Rezoning Transportation Analysis

Petition Number: 2022-134

Date	Description
01-26-23	First Review (PDM)

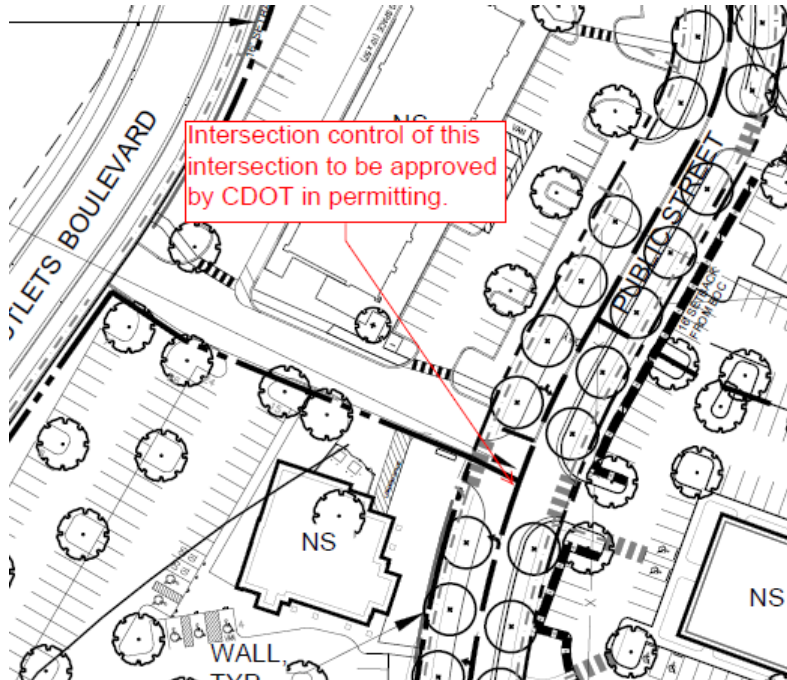
2. Provide documentation from rezoning petition #2017-019 that the \$250,000 financial contribution commitment has been satisfied or add a conditional note committing to the same contribution.
3. Add callout and conditional note for the proposed intersection control to be approved by CDOT during permitting for the below intersection.
